**Validation report form for post-registration changes for
CDM project activities
(Version 03.0)**

Title and UNFCCC reference number of the project activity	Hasang Hydro Electric Power Plant (Ref. 10632)
Process track	<input type="checkbox"/> Prior approval <input checked="" type="checkbox"/> Issuance <input type="checkbox"/> Renewal of crediting period
Version number of the validation report	1.1
Completion date of the validation report	03/08/2021
Type(s) of PRCs	<input type="checkbox"/> Temporary deviations from the registered monitoring plan, applied methodologies, standardized baselines or other methodological regulatory documents ¹ <input checked="" type="checkbox"/> Corrections <input type="checkbox"/> Changes to the start date of the crediting period <input type="checkbox"/> Inclusion of a monitoring plan <input type="checkbox"/> Permanent changes to the registered monitoring plan, or permanent deviation of monitoring from the applied methodologies, standardized baselines or other methodological regulatory documents <input type="checkbox"/> Changes to the project design <input type="checkbox"/> Changes specific to afforestation and reforestation project activities

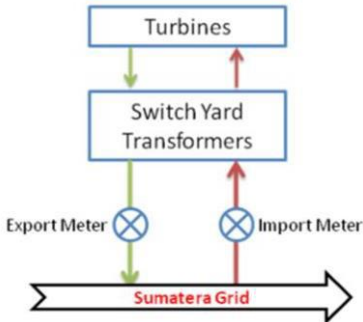
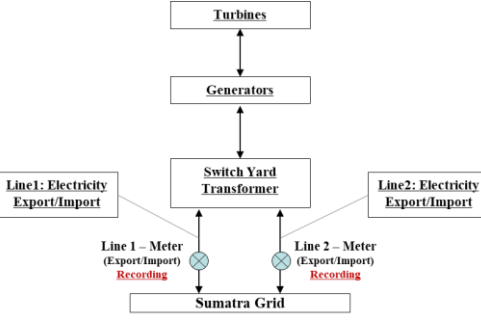
- Measurement methods and procedures / Monitoring diagram:					
	PDD Section	Registered PDD version 3.0	Revised & Proposed PDD version 4.0			
	B.7.1. Data and parameters to be monitored	Electricity meters will be installed as per requirements in the PPA. There will be two meters, one that measures the export to the grid and another that measures the import from the grid. The net electricity exported is the difference between these two meters. Data will also be cross checked with invoices.	Electricity meters will be installed as per requirements in the PPA. There will be main and check meters for each line, capable of monitoring export/import to and from the grid. The net electricity exported is the difference of export and import. The readings from both lines will be added to get the net export to grid. Data will also be crosschecked with invoices.			
	B.7.3. Other elements of monitoring plan - 8. Monitoring Diagram

Assessment Opinion
	<p>The validation team have interviewed the PP and found the registered PDD version 3.0^{/2/} was drawn up & was assessed for the function/type of the electricity meter and electricity transmission line from/to the grid, single-directional or bi-directional, with incorrect information. The PP revised the PDD^{/4/} and submitted it to the validation team with evidences^{/9/,/10/&/11/}. The PP corrected the description of the meters with more detail from 'two meters' to 'main and check meters', and from 'separate export and import meter' to 'bidirectional meter'. Monitoring diagram is corrected as per the description of the meters above.</p> <p>The validation team confirms that the electricity meters are installed as per requirements in the PPA and corresponding to applied methodology and also confirms that the revised & proposed PDD version 4.0^{/4/} correctly reflects the actual function/type of the electricity meter and electricity transmission line from/to the grid as bi-directional,</p> <p>The PP also corrected contact information, the e-mail, of the project participant and the validation team confirms it as a revision with the correct information.</p> <p>The corrections proposed by the PP is to improve the precision and clarity of the project information and the revision of the information is an accurate reflection of actual information of the project activity.</p> <p>The PP has documented these corrections in the revised & proposed PDD version 4.0 correctly and transparently. The validation team checked and confirmed that the corrections are duly reflected on the revised & proposed PDD version 4.0^{/4/}.</p> <p>The validation team confirms that the corrections do not affect the values of the registered parameters and the aforementioned corrections do not affect the capacity of the project activity nor the emission reduction of the project activity.</p> <p>Therefore, the corrections were found to be in accordance with the para. 287 to 289 of validation and verification standard for project activities version 2.0^{/6/}.</p>

Findings	No non-conformability was observed during assessment for this section.
Conclusion	KSA validation team confirms that the corrected information is an accurate reflection of actual project information and corrections made by the PP in the revised & proposed PDD version 4.0 ^{/4/} comply with the relevant requirement in para. 232 of CDM project standard for project activities ^{/7/} .
